### **REMARKS**

Applicant submits the following remarks in response to the Final Office Action of November 18, 2003 ("FOA"). Claims 18 and 21 have been amended, claim 19 has been canceled, and claims 23-27 have been withdrawn.

Annotated Marked-up Drawings

FIG. 6

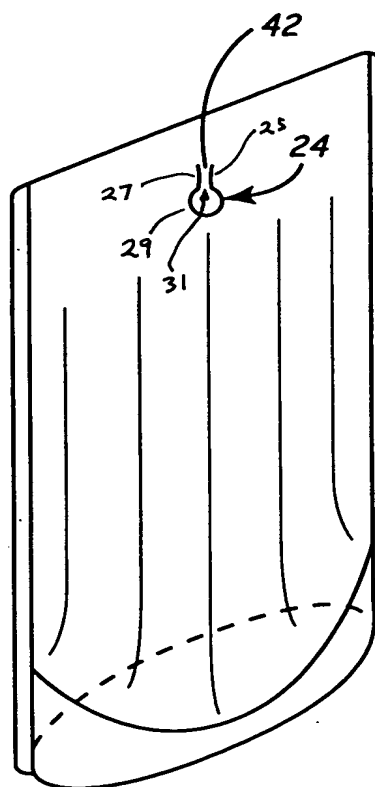
The FOA objected to the drawings for failing to show every feature of the invention specified in the claims. Specifically, the substantially straight line segments joined to each other by the arcuate line segment were not identified in FIG. 6.

The FOA objected to the specification for failing to provide proper antecedent basis for the claimed subject matter. Specifically, the FOA asserts that proper antecedent basis for the first and second straight line segments and arcuate line segment is lacking.

Applicant has amended FIG. 6 to identify the first substantially straight line segment 25, the second substantially straight line segment 27, and the arcuate line segment 29 that form the piercing point 24 and hinge 42 illustrated in FIG. 6. No new matter has been added. Applicant respectfully requests that the objection be reconsidered and withdrawn.

Applicant has amended the specification to add further discussion of FIG. 6, which clearly shows that the piercing point 24 and hinge 42 are defined by a single continuous channel that has a first substantially straight line segment 25, a second substantially straight line segment 27, and an arcuate portion or line segment 29. As clearly shown in FIG. 6, the first end of the
